18077-01-001

**Proposed Residential Development at
Athgarvan, Co. Kildare**

ROAD SAFETY AUDIT STAGE 1

July 2018

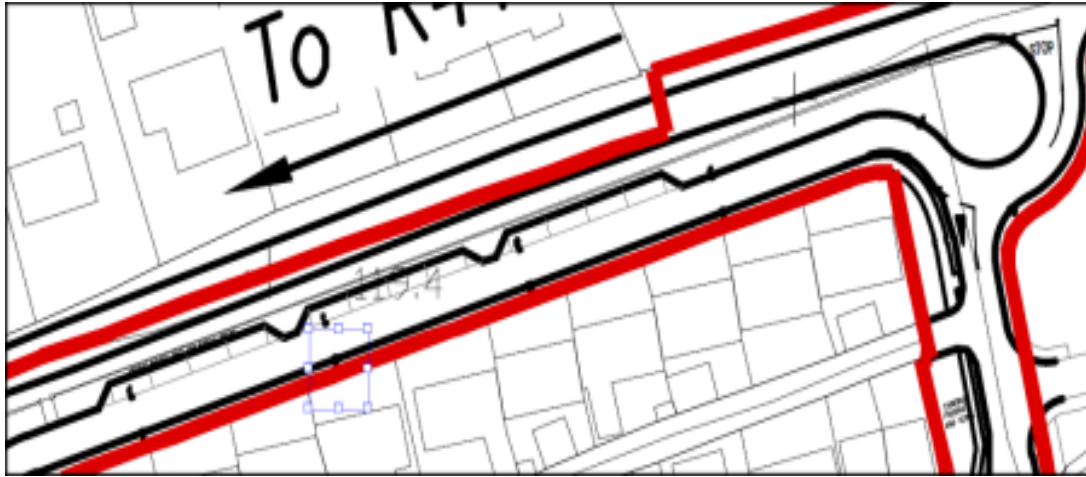
There is no footpath on the southern side of the public road. There is, however, a footpath on the northern side of the public road, which extends in both the easterly (towards the village) and westerly (towards the school) directions.

Pedestrians from this development would need to cross to road, at both the easterly and westerly end of the development, and the lack of adequate pedestrian crossing facilities could lead to an increase in pedestrian collisions at these locations

Pedestrian crossing facilities should be provided at each end of the development.

TITLE
PROPOSED ENTRANCE SIGHTLINES

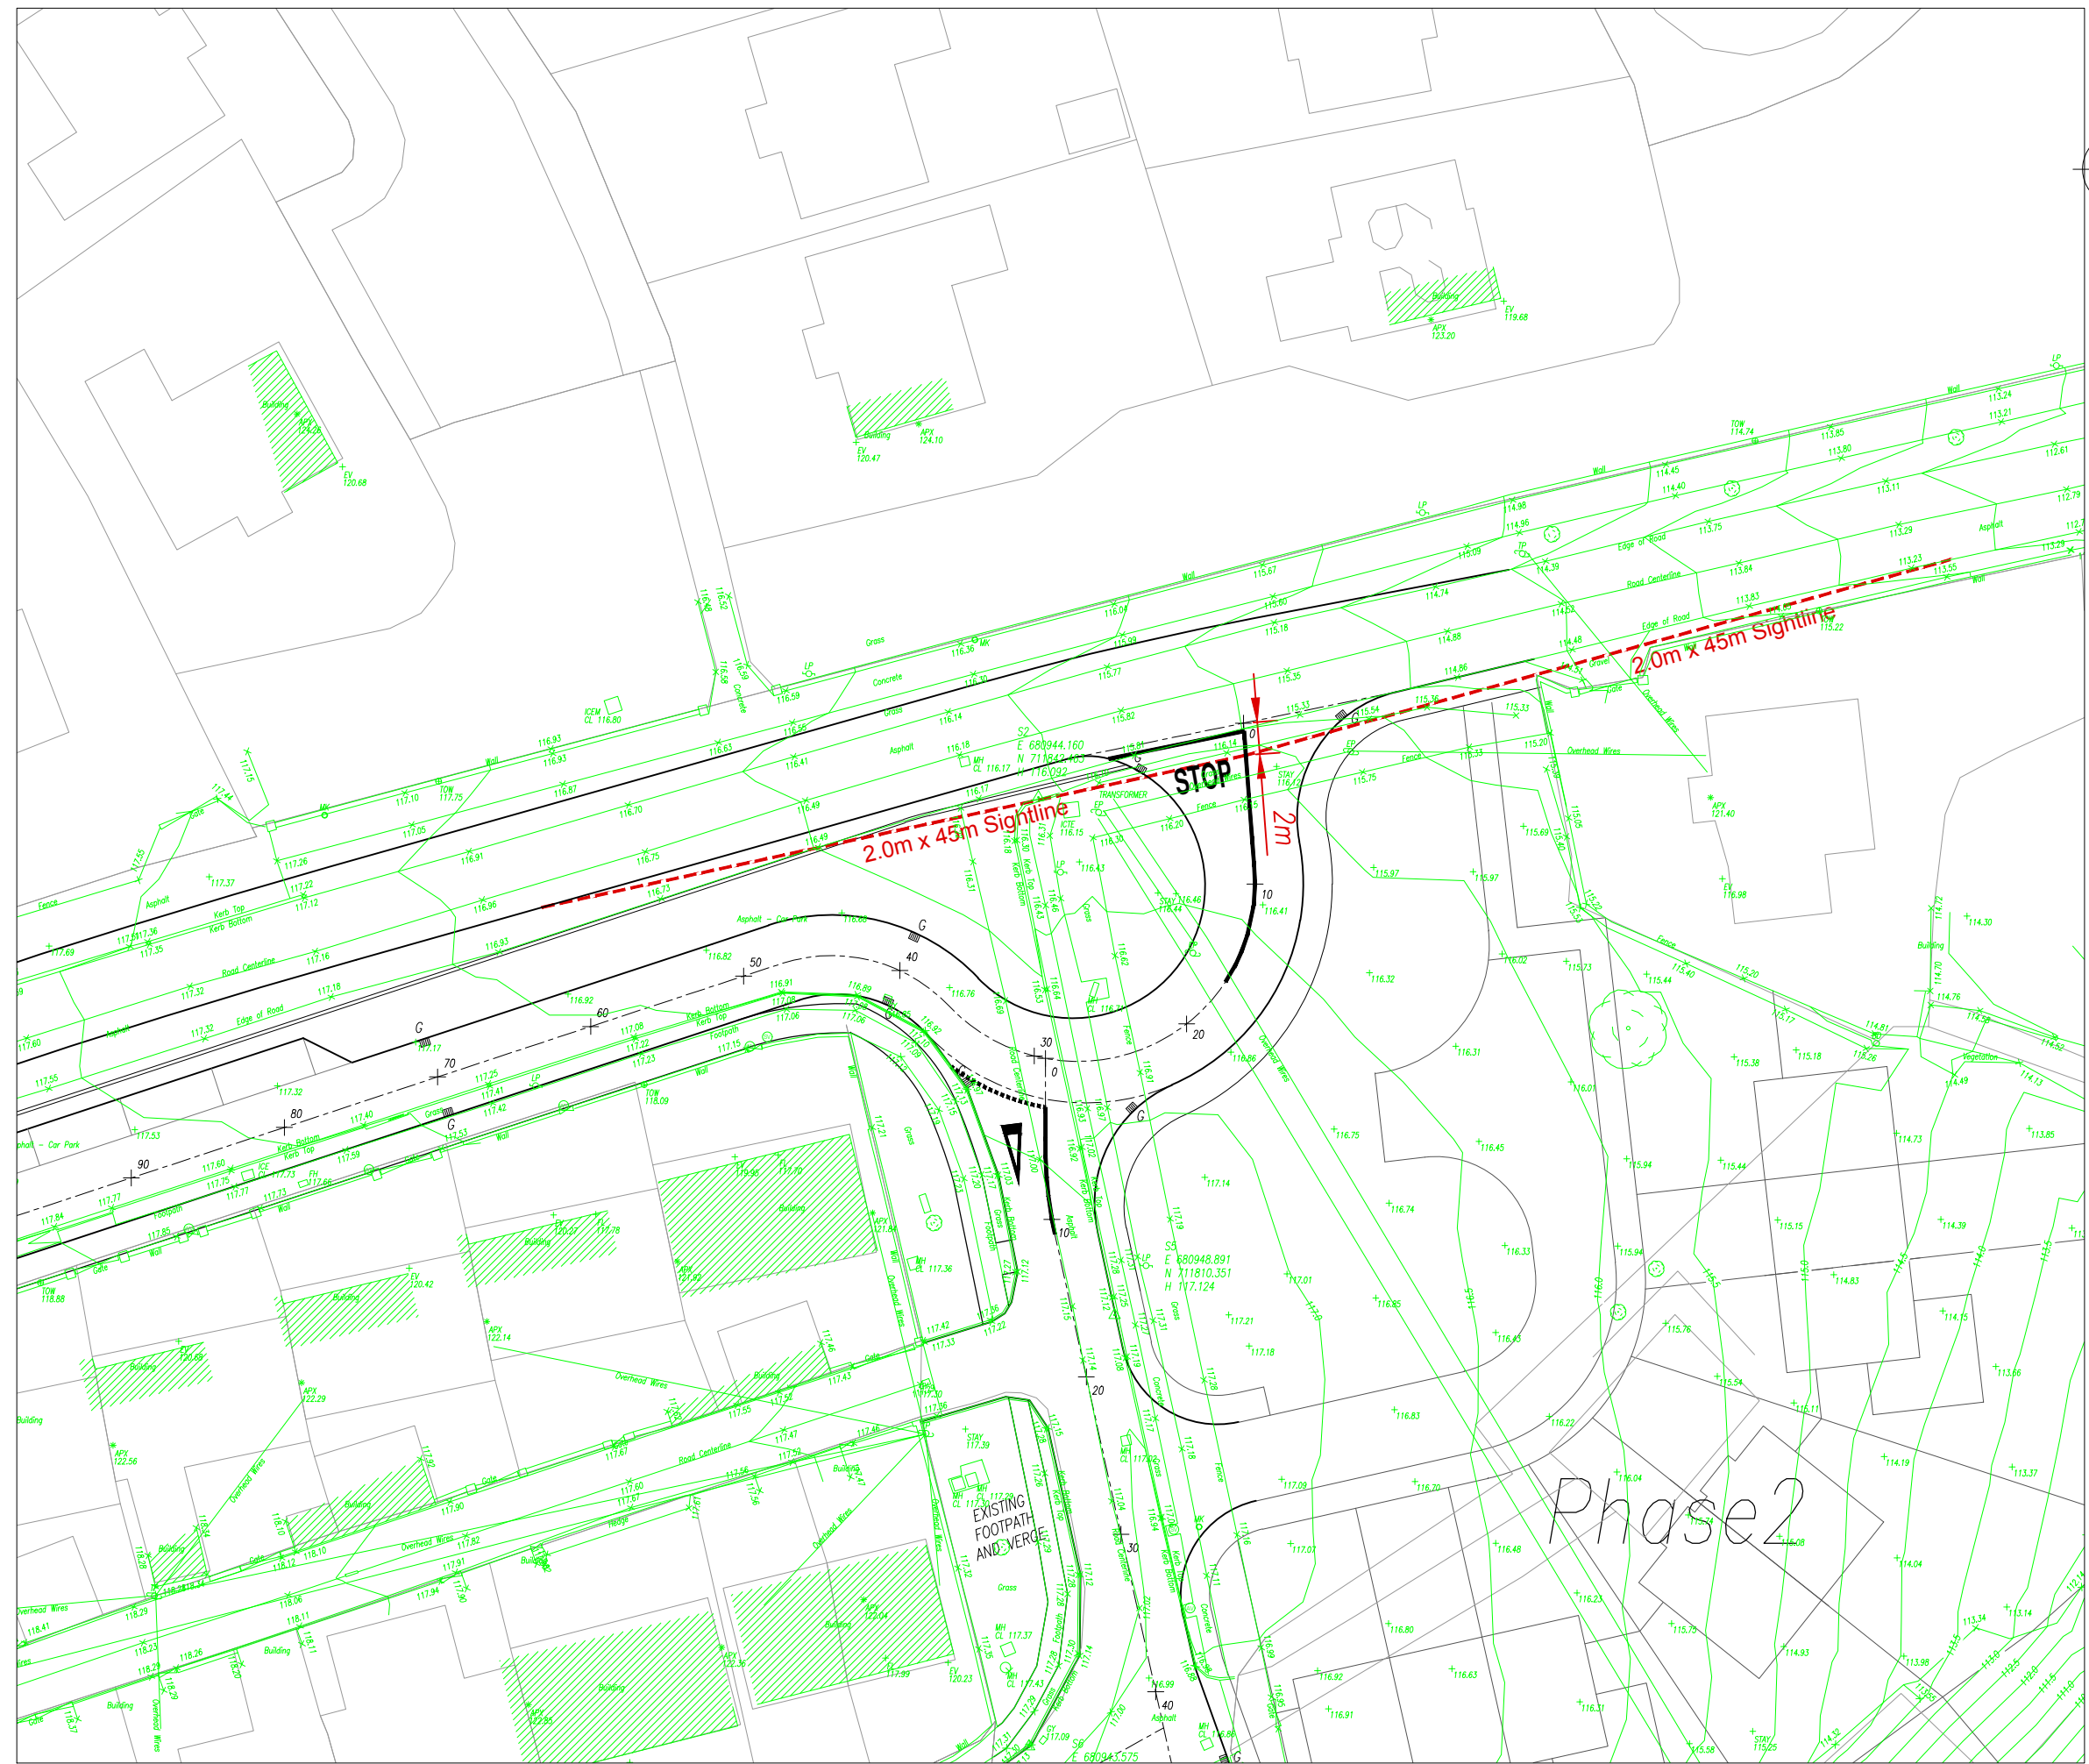
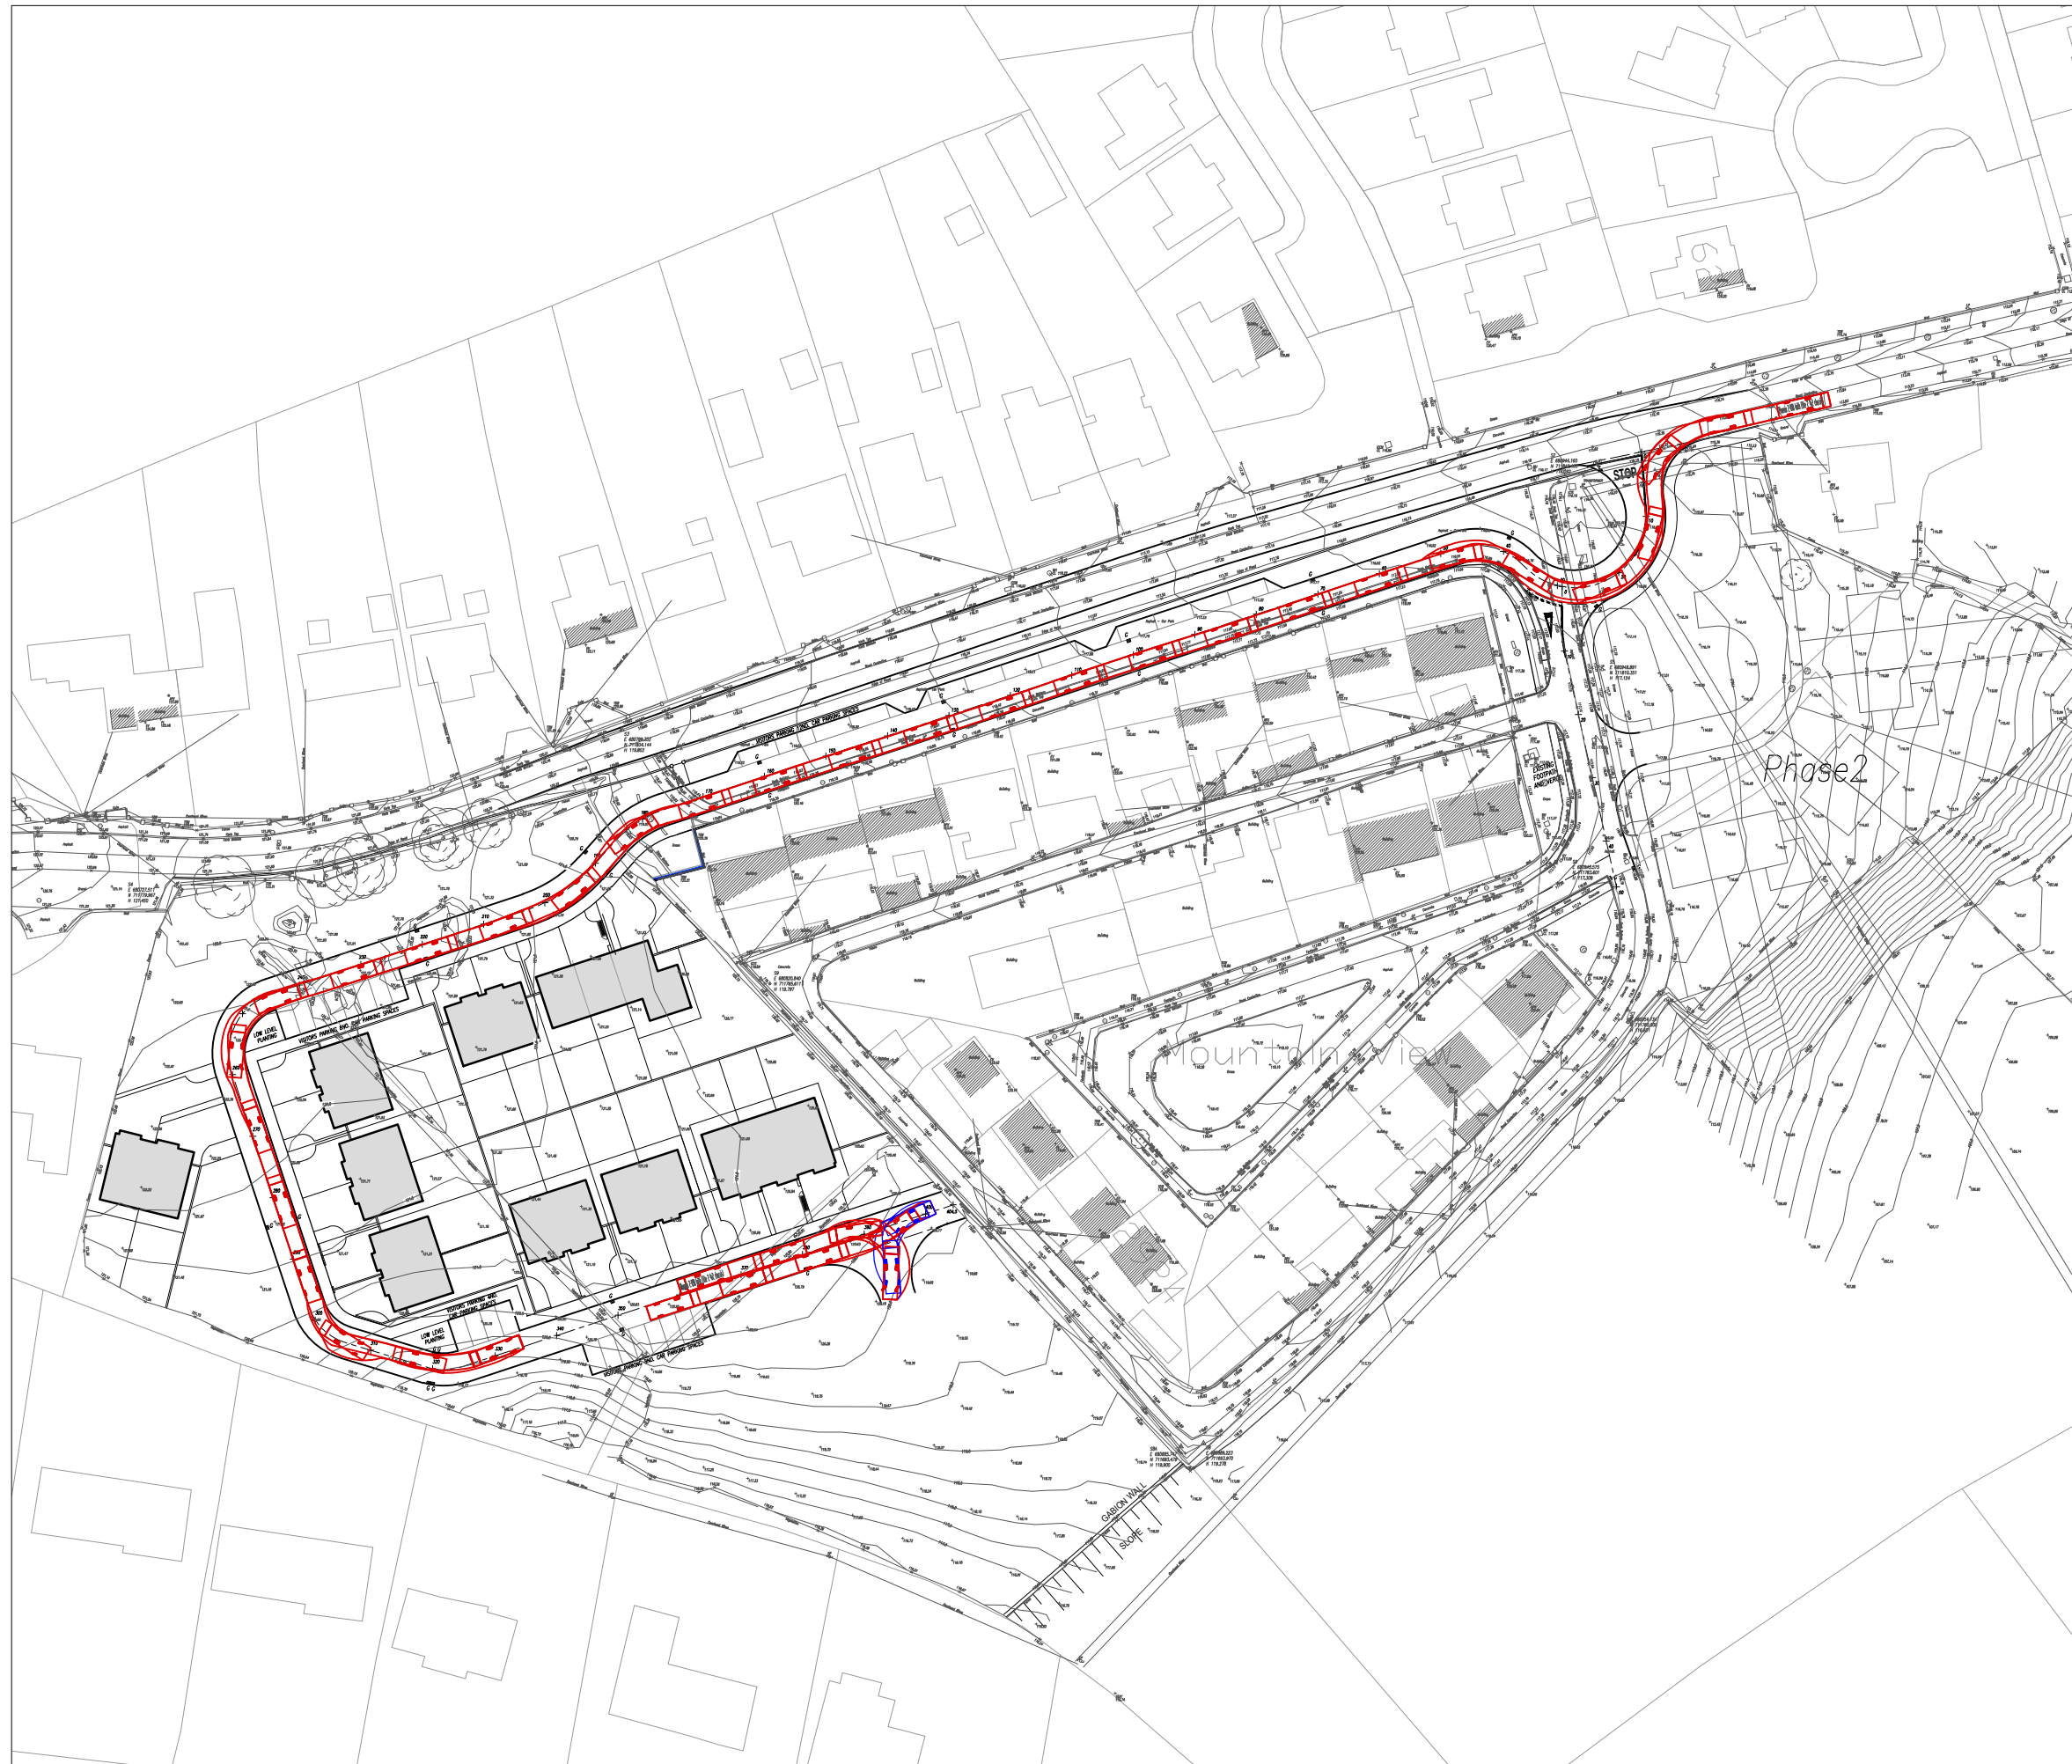
The sight distance at the entrance to the proposed housing scheme is constrained by an existing neighbouring boundary wall on the eastern side of the development.

- An 'x' distance of 2.0m may be tight at this location, particularly in light of proposing to move the existing southern road edge north of its current location in order to achieve visibility to the right.
- The taper from the existing to new road edge occurs through the junction mouth and as a result the proposed kerblines on the west side of the access may protrude out into the mainline carriageway.
- The taper lengths are short which results in an abrupt change in direction of the kerblines. This may lead to vehicles colliding with the kerblines.

Westbound drivers approaching the new junction may be following the existing road edge and may either collide with the new kerblines on the west side of the junction or a vehicle exiting the junction which is protruding onto the mainline in order to achieve adequate visibility of approaching vehicles.

A longer taper should be provided in advance of the junction, and a set-back of 2.4m for visibility splays should be provided at the access.
